Access Compliance Report

Public Rights-of-Way

(Curb Ramps)

Intersection ID: 45495	Main Street: COTTON_PRESS_RD	Cross Street: TREE_CANOPY_RD	Location: SE
ADA ID: 0075AC49535C	Ramp Type: Perp	Initial Pass/Fail: Pass	Overall Compliance: No
Severity Score: 12.5			
Codes/Mitigation Info/Possible Solution		Field Measurements/Component Compliance

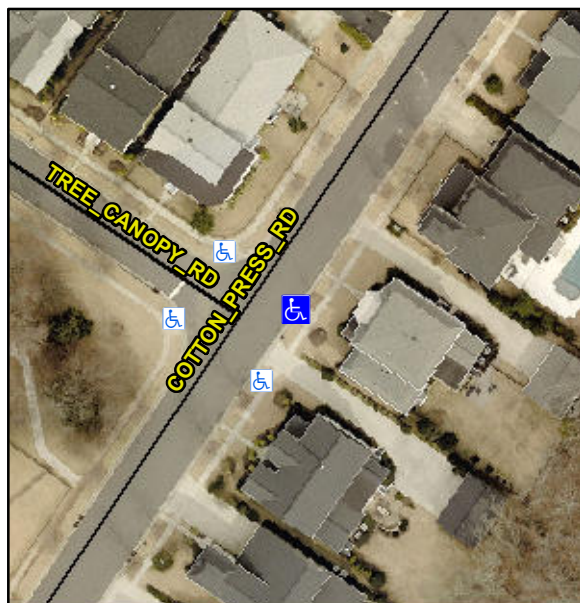
**Not Found, R304.2.2-Perp, R304.3.2-
Para, R304.5.3, R302.7.2, R304.5.4**

Compliance	Description	Data	Compliance	Description	Data
N/A	Ramp Length (in)	72.0	Yes	Ramp Slope (%)	6.4
Yes	Ramp Width (in)	48.0	Yes	Ramp XSlope (%)	1.1
N/A	Flare Type LT	Sloped	N/A	Flare Type RT	N/A
N/A	Flare Slope LT (%)	9.5	Yes	Flare Slope RT (%)	4.4
N/A	Flare Traversable LT?	Yes	N/A	Flare Traversable RT?	Yes
Yes	Landing Length (in)	48.0	Yes	DWS Provided?	Yes
Yes	Landing Width (in)	48.0	Yes	DWS Contrast?	Yes
No	Landing Slope (%)	2.9	Yes	DWS Length (in)	24.5
No	Landing X Slope (%)	2.6	Yes	DWS Full Width?	Yes
N/A	Landing Curb? (Y/N)	No	Yes	DWS Offset (in)	0.0
N/A	Shared Landing?	No			
Yes	Gutter Ponding?	No	No	Gutter Slope (%)	12.5
No	Gutter Lip Ht (in)	0.5	Yes	Gutter X Slope (%)	2.0
N/A	Painted X Walk1?	No	N/A	Painted X Walk2?	N/A
	X Walk 1 Direction	To NW		X Walk 2 Direction	N/A
N/A	X Walk 1 Width (in)	N/A	N/A	X Walk 2 Width (in)	N/A
	X Walk 1 Slope (%)	2.0		X Walk 2 Slope (%)	N/A
	X Walk 1 X Slope (%)	2.4		X Walk 2 X Slope (%)	N/A

N/A	Ramp inside XWalk1?	N/A	N/A	Ramp inside XWalk2?	N/A
	Road Slope (%)	N/A	N/A	Clear Space?	Yes
	Road X Slope (%)	N/A	N/A	Clear Space to XWalk (in)	N/A
Yes	Any Obstructions?	No	Yes	Storm Grate/Utility Hazard?	No
	Obstruction Type			Storm Grate/Utility Type	
		N/A			N/A
			Yes	Surface Condition? (G/P)	Good

**Remove & Replace Entire Ramp.
Remove & Replace Gutter.**
